18-21497
ENGINEERING COMPLIANCE
City of Dublin
APPROVED AS NOTED
CG 9/10/18

BUILDING CO. <u>DAVIDSON-PHILLIPS, INC</u>	SCALE: <u>1" = 20'</u>
LOT NO. <u>30</u>	SUBDIVISION <u>BRIGHTON PARK</u>
STREET ADDRESS <u>5692 RICHGROVE LANE</u>	DRAWN <u>1-12-94</u> SHT. NO. <u>1/1</u>

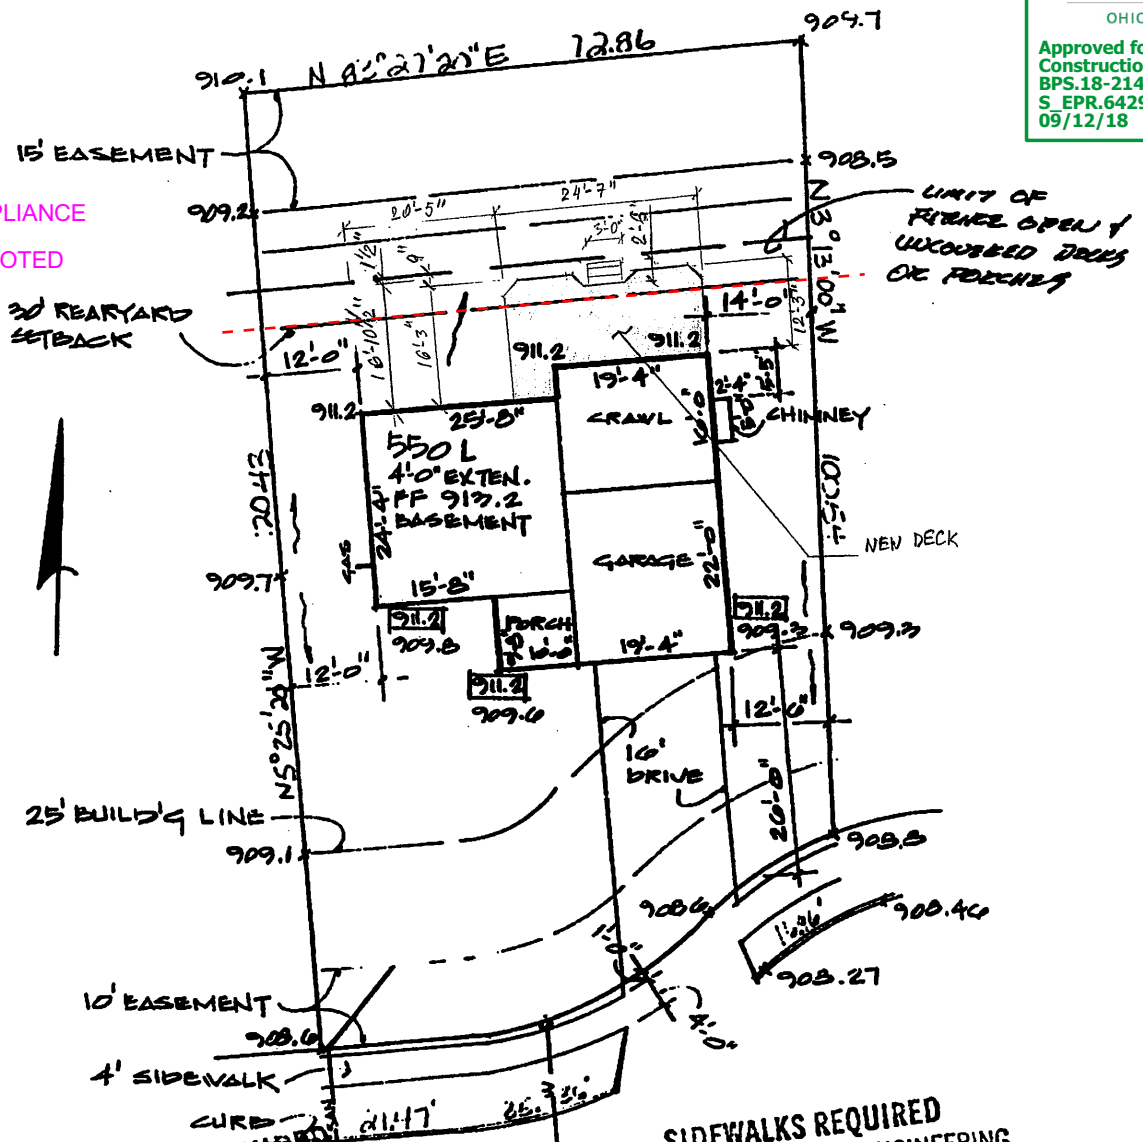
STREET TREES REQUIRED
Contact Paula Chope, Urban Forester
To Coordinate - 761-6520

SIDEWALKS REQUIRED
CONTACT GARRY CLARK, ENGINEERING
TO COORDINATE 761-6550
